## Comments and recommendations on IAA Guidelines for Bruce C project.

Sunil Nijhawan, PhD P.Eng

## DESIGN ISSUES WITH CANADIAN MULTI UNIT CANDU REACTORS AT BRUCE & DARLINGTON AND THE VULNERABILITIES IN THEIR DESIGN THAT BRUCE POWER AND OPG SHOULD FIX

11 JULY 2025

**Figure 1 : Lower than core placement of pressurizer that will drain boiler tube inventory at Darlington reactors in a station blackout scenario (not a low frequency event)**

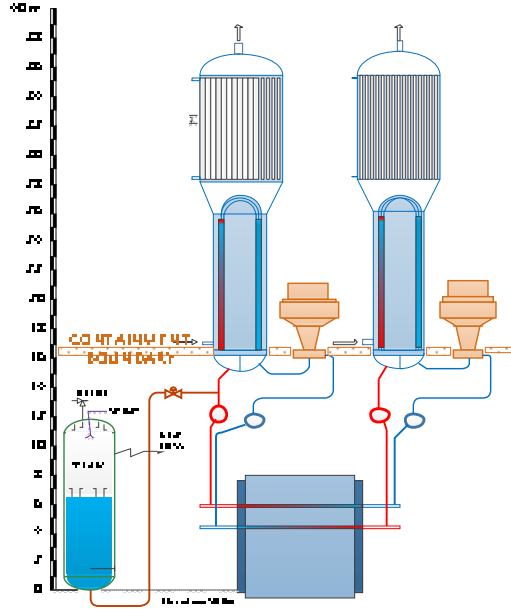
The strange choice of pressurizer location below the boilers and reactor headers (in 12 reactor units at Darlington and Bruce stations) will cause draining into it of primary coolant from boiler tubes in a SBO to an extent that boilers will become useless as heat sinks and no amount of emergency measures to add water to boilers will restore cooling to the reactor core unless the primary cooling system was replenished as well, something that cannot be done after an SBO in the present design and presently configured SAMGs.

3. Emergency power hookups to pressurizer heaters for early re-establishment of pressure control, or Relocate pressurizer to higher elevation
4. High pressure makeup of PHTS inventory loss (high pressure emergency water injection pumps)

**Figure 4 : Looking into gravity feed into the boilers from de-aerator**

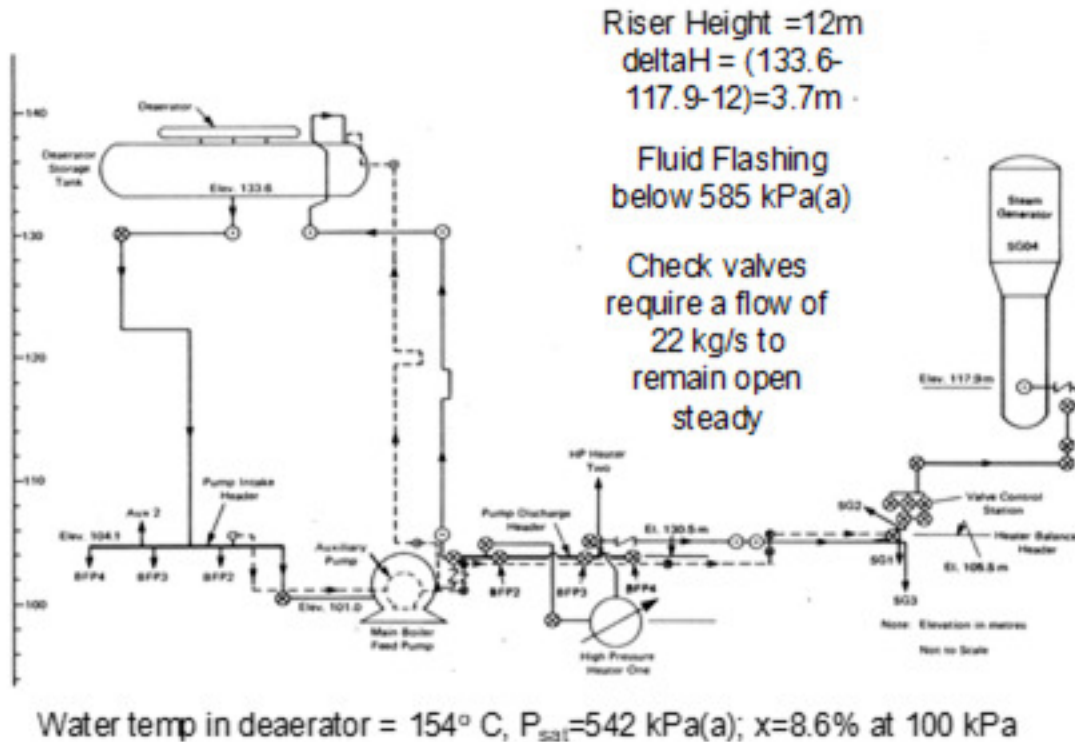
The current SAMGs erroneously credit gravity feed of water into the boilers after their depressurization through the feedwater train from de-aerator. This will really not work. Flashing of the ~160°C water inventory and unavoidable high pressure back leakage of boiler inventory through the check valves would vapour bind the feedwater flow path. In addition, there will not be enough driving force to open and then keep the feedwater check valves open.

This happens as a lack of a decay heat level controlled steam relief on the Calandria vessel (which contains the moderator) accelerates severe core damage by ejecting a significant amount of moderator when it becomes the dominant heat sink for fuel channels, boils and causes the rupture disks on its large piping to burst to eject water by flashing and carryover. By ignoring the extra 30-60 min such a design omission subtracts from time to onset of severe core damage, the industry reinforces its intransigence and inability to think through that public safety supersedes all other considerations .

**Figure 5: Calandria vessel, a stepped stainless steel vessel with welded annular plate**

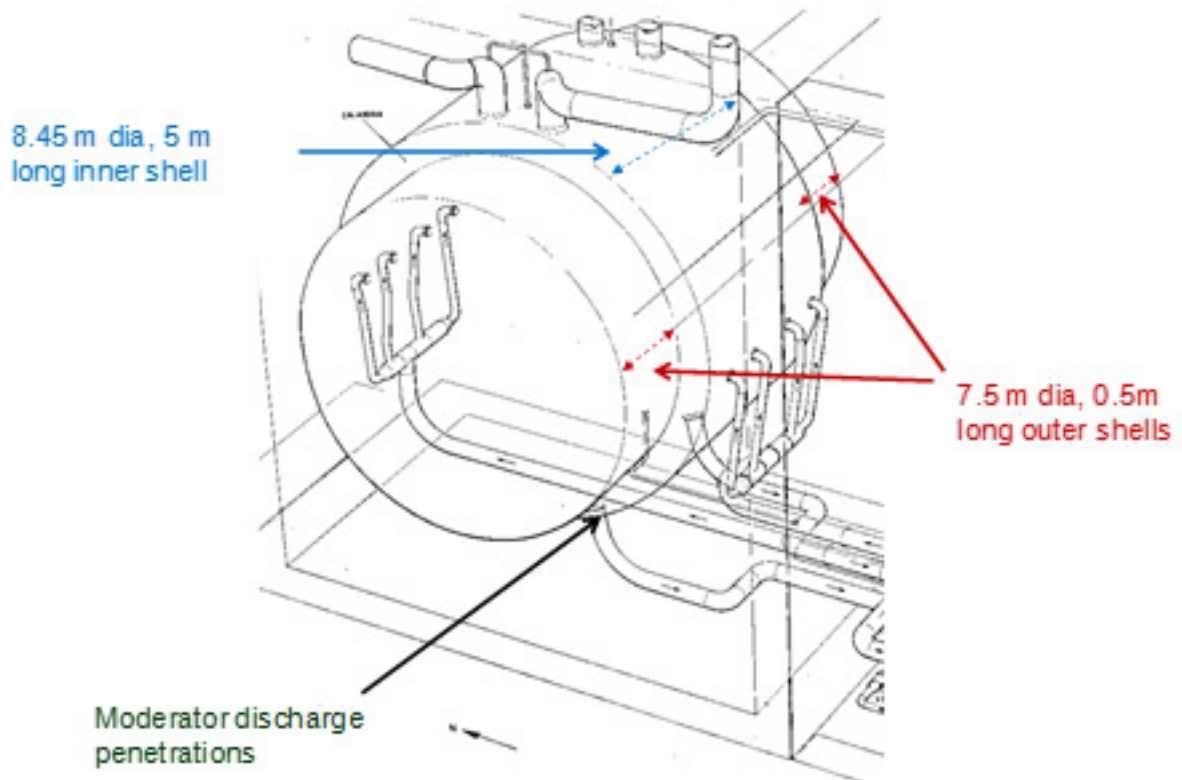
Accident termination by retention of molten core debris in a vessel have been adopted from PWRs without consideration of the design specifics of the stepped low pressure and thin CANDU moderator vessel. The debris formation in a CANDU reactor is in solid chunks of fuel channel and its eventual retention upon Zircaloy melting in the Calandria vessel cannot be guaranteed as the relatively thin walled stepped and welded vessel (wall thickness varying between 19 and 28 mm) may fail at welds by thermal loads long before any gross melting thus violently introducing water from the shield tank onto hot debris.

**Figure 6 : Likely state of debris upon Calandria weld failure**

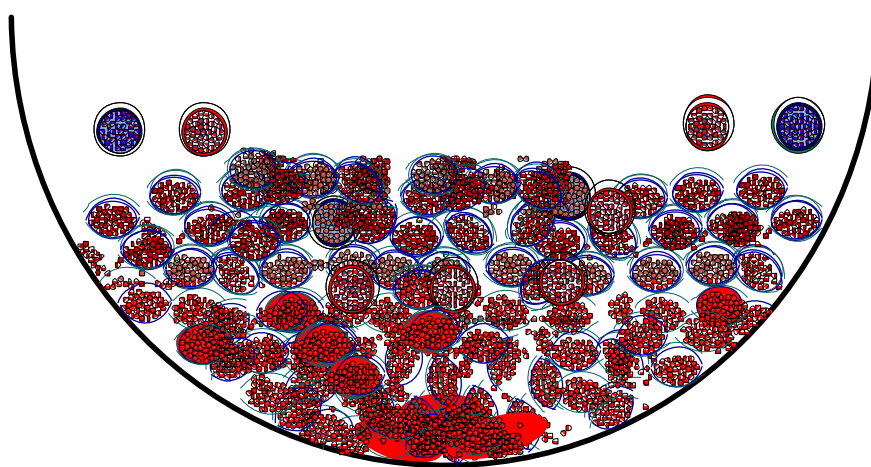
Any claims of an LWR like in-vessel retention of molten uranium debris are not credible or consistent with the gradual core disassembly of CANDU cores in case of a station blackout scenario with a sustained absence of heat sinks. The Calandria vessel has a wall thickness that varies between 19mm at annular plates to 28 mm in main shell. The weld failure upon differential expansion of the two shells, with outer shell constrained, is easy to demonstrate (Figure 6 and Figure 7 ).

The effect of Calandria vessel weld failure can vary from additional hydrogen production, accelerated fission product releases as one mode of outcome for small weld cracks and slow leaks, to catastrophic vessel failures by energetic interactions of incoming water with the hot and molten solid-liquid debris at the bottom of the Calandria vessel as the other mode.

**Figure 7: Calandria shell elongation as an indicator of stresses that will cause weld failure**

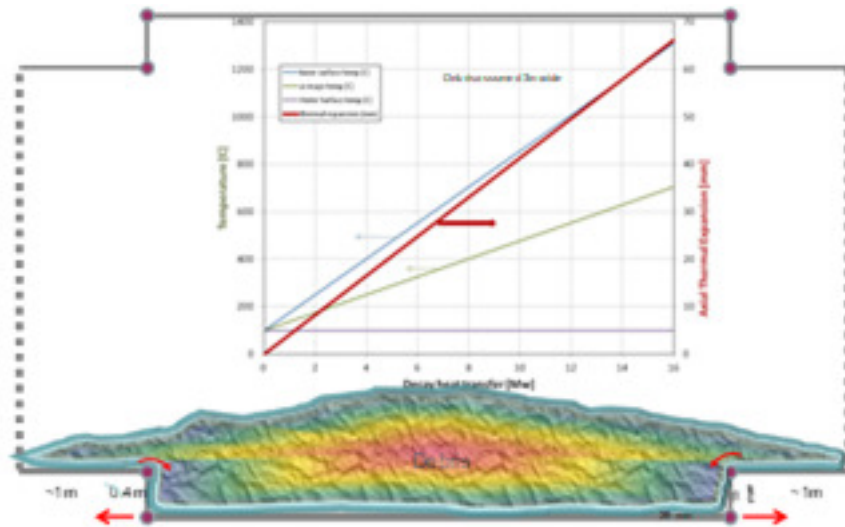
As a result of absence of a retaining vessel, direct un-attenuated releases into the containment, weak containment structures and significant likelihood of energetic interaction of hot debris with water and Deuterium burns /explosions causing challenges to containment integrity, large releases of radioactivity from failed containment structures are inevitable.

**Figure 8: Multi unit layout at Bruce station; Darlington is similar**

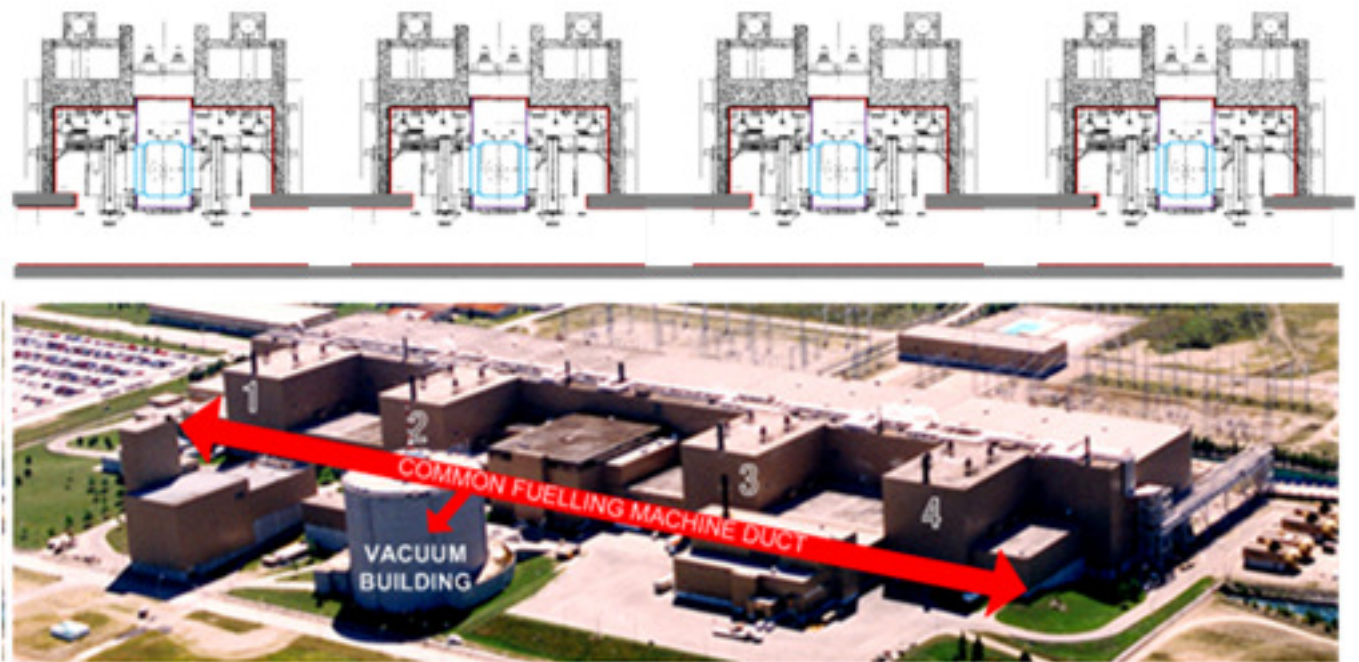
The reactor buildings around each individual reactor core are inverted cup like traps for combustible gases (Figure 8). A large number of safety significant components like the steam generators, pumps and the reactivity control devices are all outside the containment envelope and vulnerable to failures by external impact or otherwise of the weak structures on top of the reactivity decks. These are some of the vulnerabilities that can be fixed.

**Figure 9: Single unit reactor assembly in a crowded vault with common fuelling machine duct below**

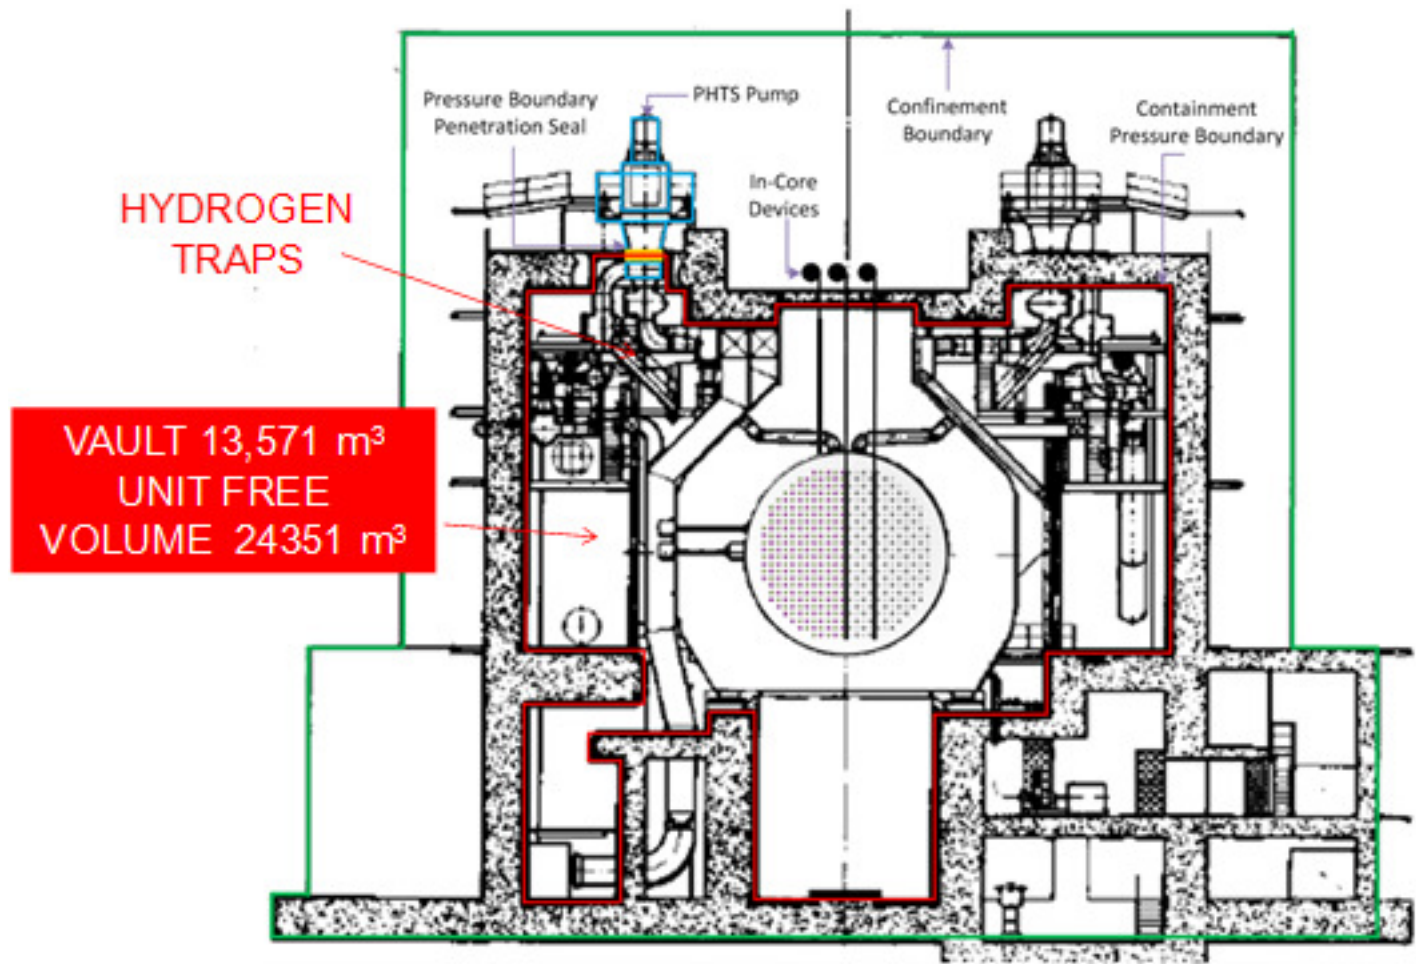
The containment layout is such that even a 1% oxidation of any of these materials will cause stagnated and explosive pockets of combustible Deuterium and Hydrogen in reactor vaults shaped like interconnected inverted cups. The reactor vault is the direct recipient of products of reaction with hot fuel as the moderator relief pipes vent into the reactor vault.

The production of combustible Deuterium gas from over ten km of carbon steel piping and over 50 tons of Zircaloy in each Darlington unit can be extremely high with steel oxidation more problematic over the longer term; making the installed numbers and types of PARS not only inadequate but as early ignition sources also dangerous.

**Figure 10 : Darlington station layout for 4 units with common containment**

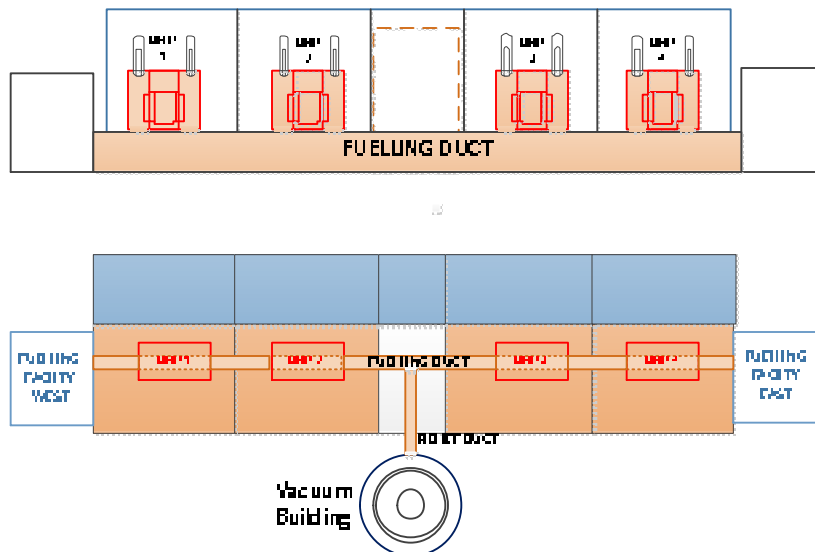
With an over pressure retention capability of less than a bar (at design and significantly deteriorated after 20+ years such that all containments are no longer tested at design pressure or at the required frequency of 6 years) and a containment structure made up of rectangular concrete slabs and about 500 times leakier than the 1%/day leakage at design pressure for PWRs, a number of critical equipment are outside the containment and some critical equipment like pressurizers are placed below the mid elevation of the reactor core inside the containment. A common Fuelling Machine Duct underlying the 4 reactors connects the containment volume via a Pressure Relief Duct to a Vacuum building whose volume is deemed adequate for most design basis accidents in a single unit but its effectiveness to mitigate a severe accident in all 4 units is very obviously lacking as the effective volume per reactor unit is less than half of that for a typical PWR and the structures are weaker and with greater likelihood of trapping combustible gases. The containment is built to the National Building Code as are the access requirements, fire protection, smoke detection, etc. It is not built to modern nuclear containment standards.

A number of reactor systems including the reactivity control mechanisms, primary pumps and steam generators are located outside the containment boundary above the reactor cores. The reactor core related structures themselves are within a tank attached at the containment pressure boundary. Critical structures essential for maintaining core cooling being outside the containment are likely vulnerable to certain externally induced challenges. The stations have not considered reactor building reinforcements to avoid building failure or added additional reinforcements with special emphasis on confinement space on top of reactivity decks to mitigate external impact hazards. While a PWR containment may be expected to withstand an aircraft impact, there is such no protection in a multi unit CANDU.

**Figure 11 : Building basement layout below Lake water level. The emergency power supply generators are at grade level with cable tunnel 6m under.**

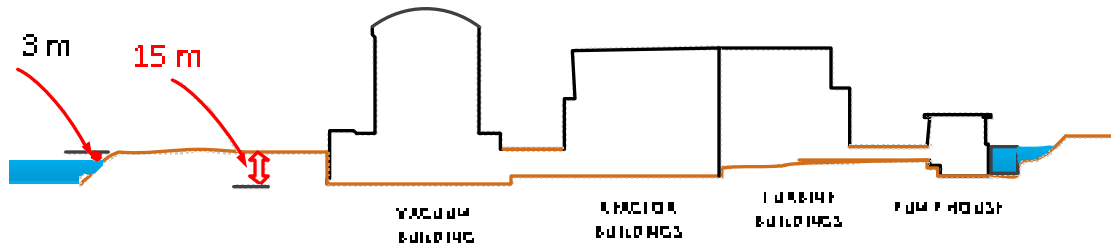
The basement of the reactor buildings (fuelling machine duct and the pressure relief duct) is located below the level of the water in the lake. To the credit of the utilities, new portable Emergency Diesel Generators have been to be located at elevations higher than the original backup Diesel Generators that are at lower grade elevations, about 3m higher than the water, not dissimilar to what sank Fukushima. They are yet to be relocated to higher elevations. If that was done a failure similar to that at Fukushima could be avoided.

**Figure 12 : Comparison of a PWR containment design pressure leakage with that for a Multi unit CANDU.**

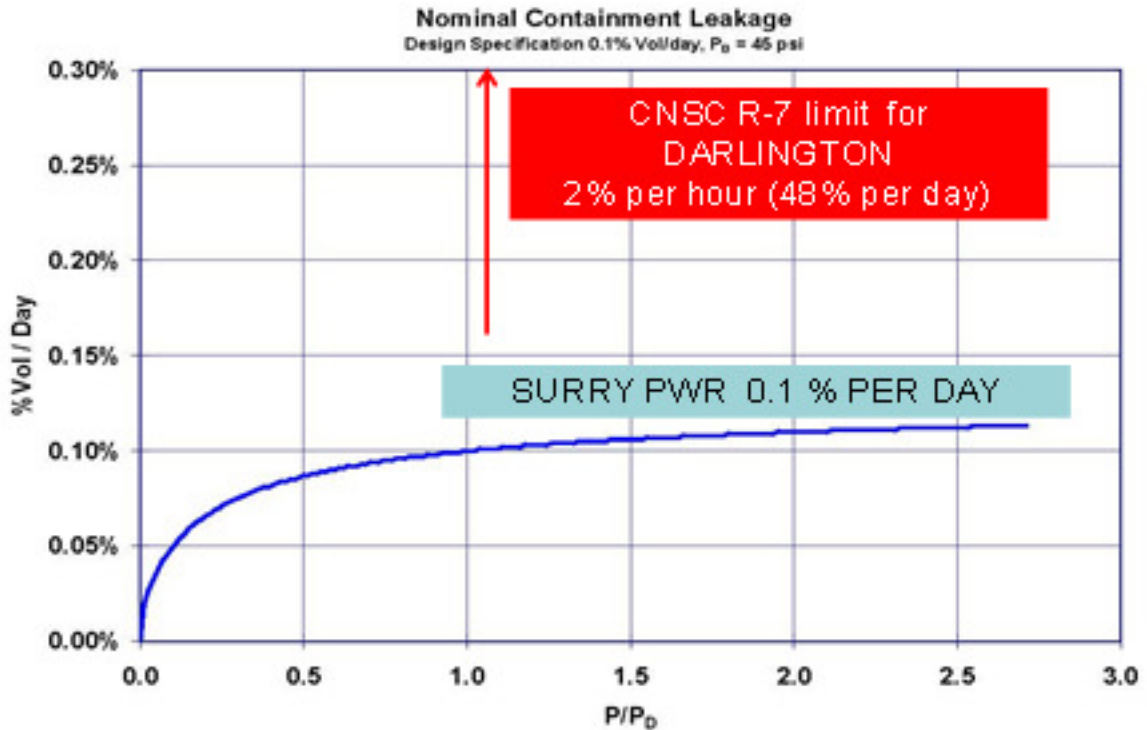
The containments are tested for pressure retention most infrequently of any power reactor in the world. Darlington now tests containment for pressure every 12 years while the regulations under which it was originally licensed required a 6 year test interval. The last pressure test was described as a difficult and arduous process that took 6 months of planning.

The individual reactor buildings can be envisioned to be inverted cups on top of a common duct such that retention of flammable gases and fission products after the vacuum building becomes ineffective is a concern. The reactor building volumes are about 14000 m<sup>3</sup> each with a combined volume of the 4 unit reactor buildings and the common fuelling machine and pressure relief ducts of about 120,000 m<sup>3</sup>. The normally isolated vacuum building is an additional 95,000 m<sup>3</sup> and it is maintained originally at an isolated pressure of 7 kPa(a) with the main containment volume slightly sub atmospheric. For a multi unit severe accident, the containment volume per unit power is among the smallest of any other similar power reactor in the world.

Figure 13: Spent fuel bundles stacked like fish in a fish basket, 16 or more trays high

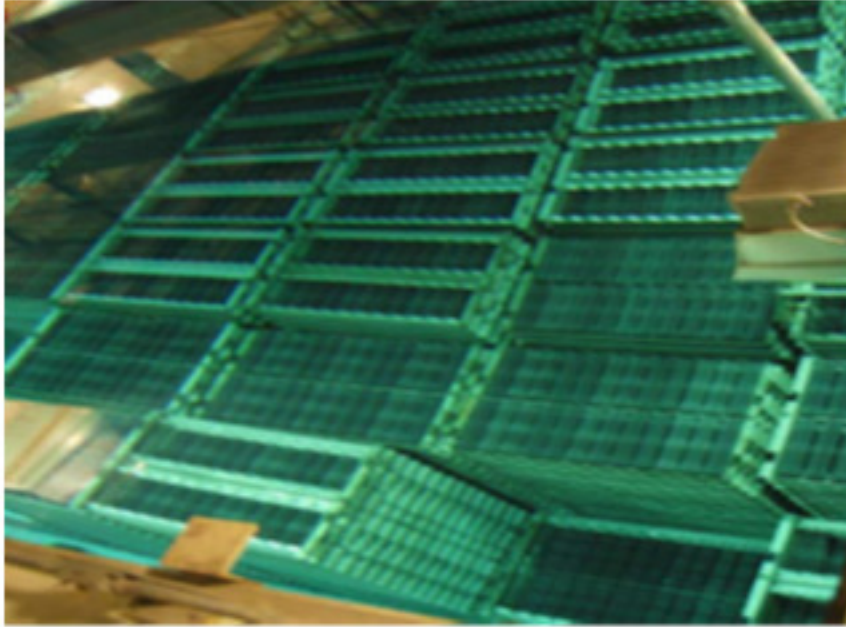
The spent fuel medium term storage in spent fuel pools is poorly designed and highly susceptible to Zircaloy fires.

17. External water makeup to a stranded fuelling machine after a LOCA
18. External water makeup and heat removal from the spent fuel bay
19. Off-site measurements of activity magnitude and energy for identification of radioactive species in releases and correlating them to source terms;
